ZHL-1042J+ PCN Report

AN-60-070

As a result of the introduction of assembly option at an alternate qualified Mini-Circuits facility, the replacement part has been judged by the Mini-Circuits Engineering team as a suitable replacement for the existing ZHL-1042J+.

COMPARISON PERFORMANCE CURVES^a: $T_{AMB}=25^{\circ}C$

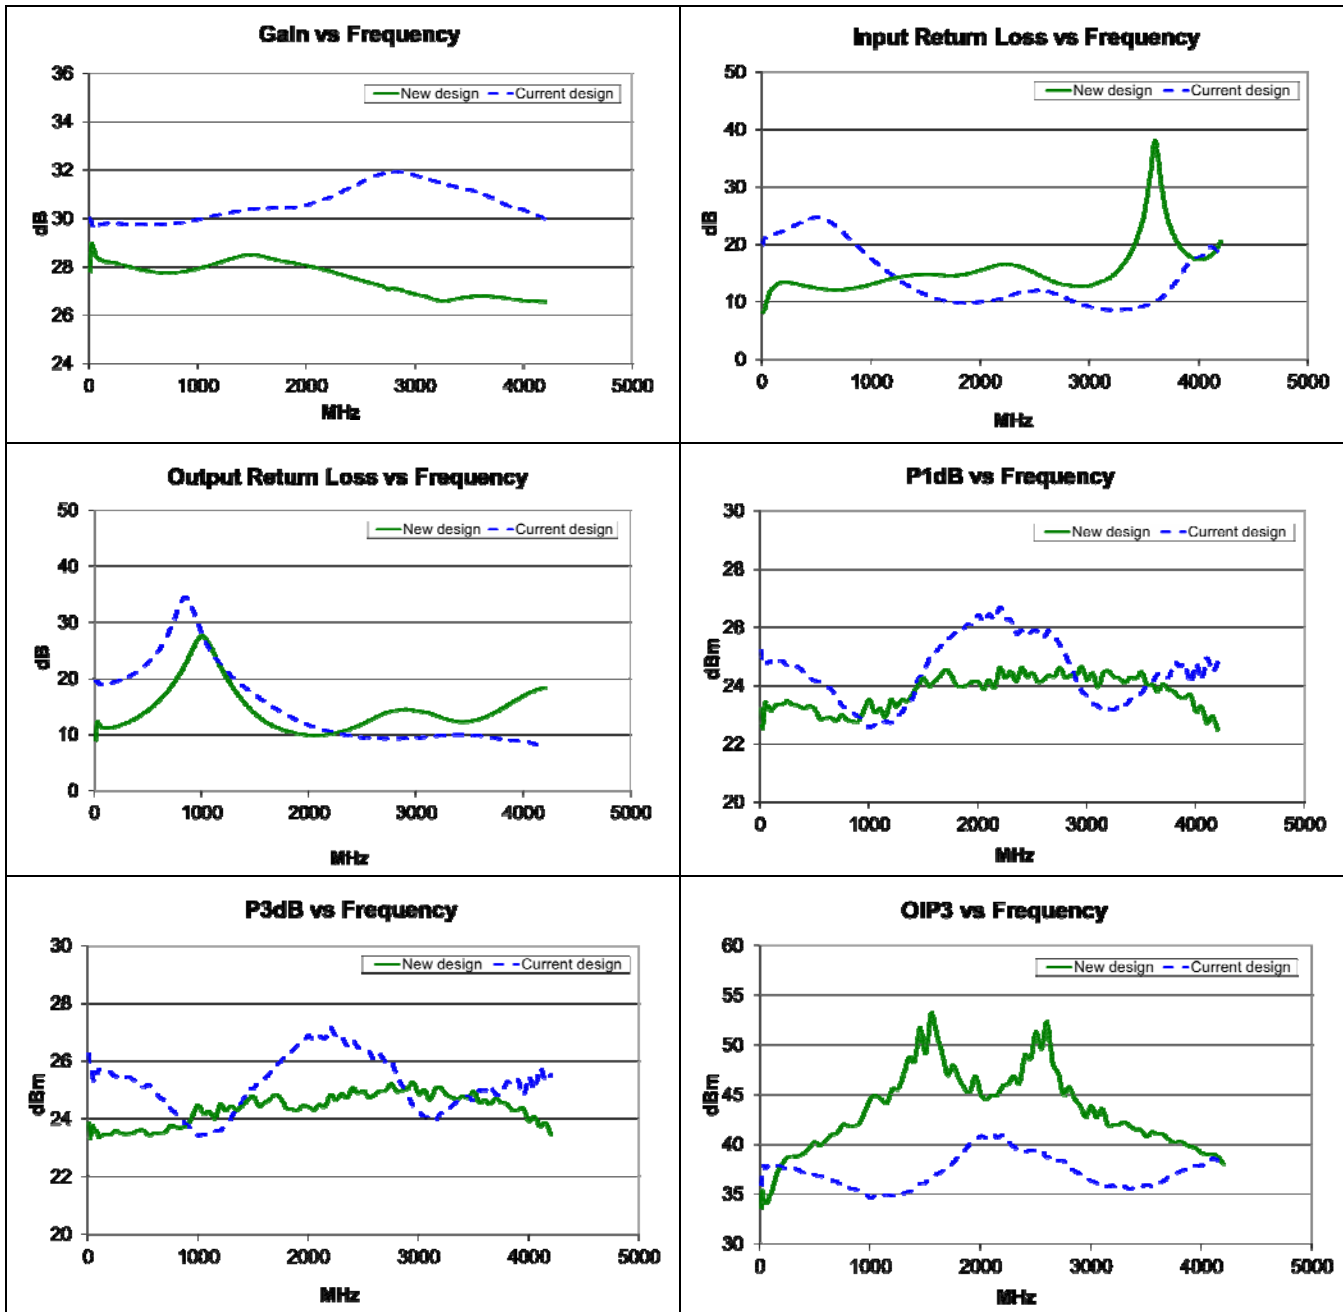
- 3) TYPICAL PERFORMANCE COMPARISON_a: T_{AMB}=25°C

Parameter	Freq (MHz)	Current design		New design	
		Min	Max	Min	Max
Gain (dB)	10-4200	29.71	31.91	26.49	28.96
Gain Flatness (dB)	10-4200	-----	+/-1.17	-----	+/-1.2
Input VSWR (:1)	10-4200	-----	2.19	-----	2.29
Output VSWR (:1)	10-4200	-----	2.39	-----	2.11
P1dB (dBm)	10-4200	22.56	-----	22.25	-----
P3dB (dBm)	10-4200	23.43	-----	23.26	-----
OIP3 (dBm)	10-4200	34.85	-----	32.28	-----
Noise Figure (dB)	10-4200	-----	5.32	-----	5.21
DC Voltage (V)	-----	-----	15	-----	15
Supply Current (A)	-----	-----	0.25	-----	0.27
